DATE: 30th March, 2005
NAME: Yair Darshan
COMPANY/AFFILIATION: PowerDsine
E-MAIL: yaird@powerdsine.com

REQUESTED REVISION:
STANDARD: IEEE Std. 802.3af-2003
CLAUSE NUMBER: 33.2.8.8
CLAUSE TITLE:

New Figure 33-7

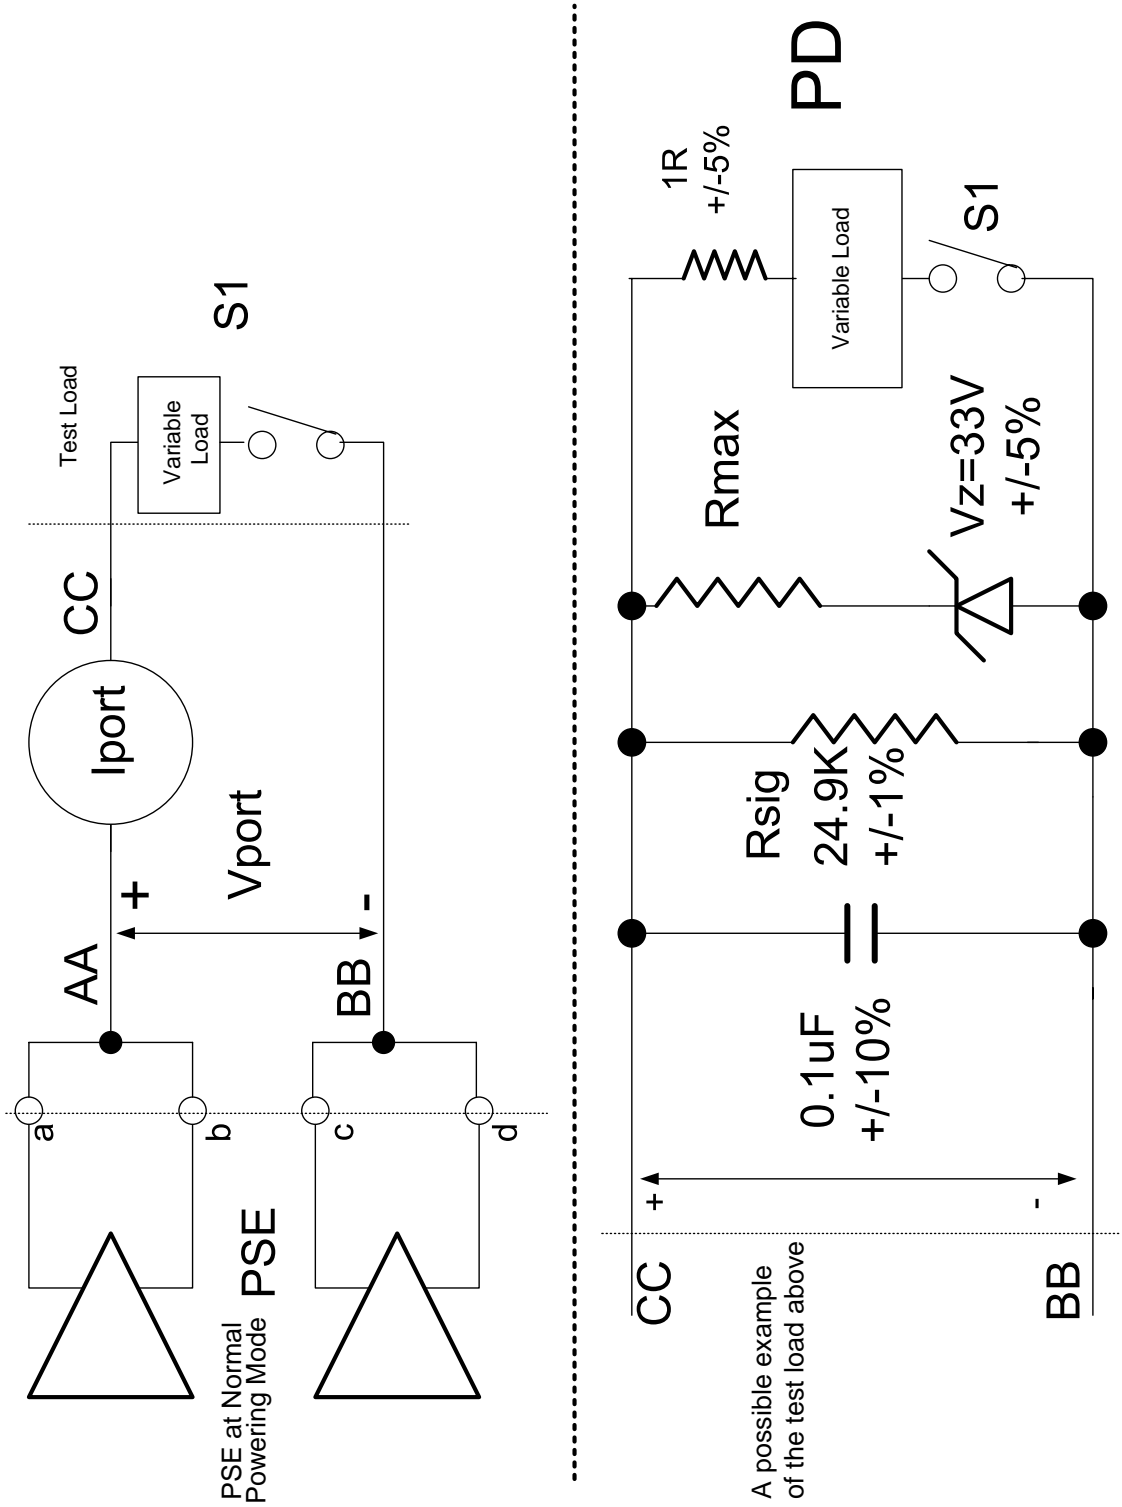
While the specifications for foldback current limit are clear from paragraph 33.2.8.5 items d and e, the reader needs to do some detective work to figure out that similar specification are apply for short circuit condition by looking at figure 33-7 which describes Inrush current and short circuit as "detect short" and by looking at figures 33-4 (right corner with "Vport>30V" label) and figure 33-6 (at the upper part

Figure 33C.6.1 – I_{LIM} and I_{NRUSH} requirements as function of V_{port} at startup and short circuit conditions

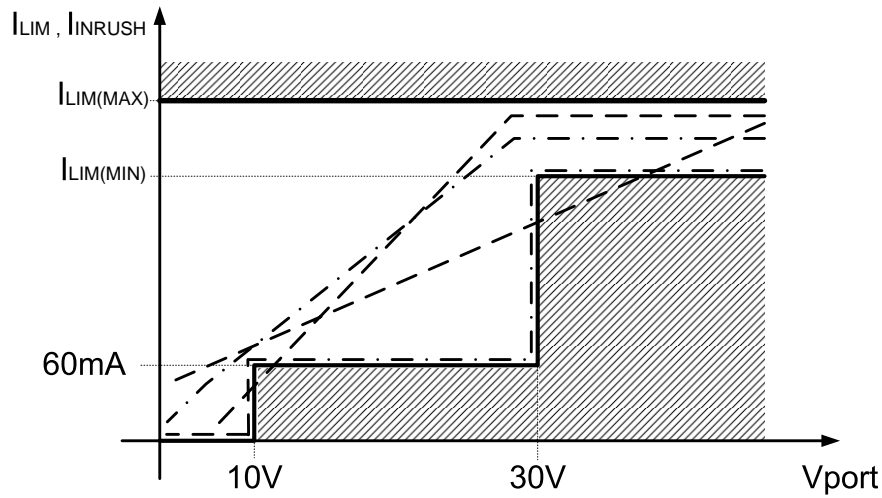
1. Add figure 33C.6.1 right after figure 33C.6.
2. In Figure 33C.7 upper part: add a box labeled "variable load" in series to S1
3. Replace test procedure PSE-7 item 3 text from:
- 3) Verify that I_{port} is within the limits shown in Figure 33C.4

2. Paragraph 33.2.8.5 item e was updated to reflect the addition of figure 33C.6.1 and to clarify the current levels for the range between 0V to 10V.

3) Change the variable load in order to verify that I_{port} is within the limits of Figures 33C.4 and 33C6.1. Please note that the variable load type (resistive, constant voltage or other) depends on different PSE implementations.

Change item 3 in PSE 4 from "Verify that ..in Figure 33C.4" to "Verify that ..in Figures 33C.4 and 33C.6.1"

To: "Test setup.....expected per Figure 33C.4 and 33C.6.1."
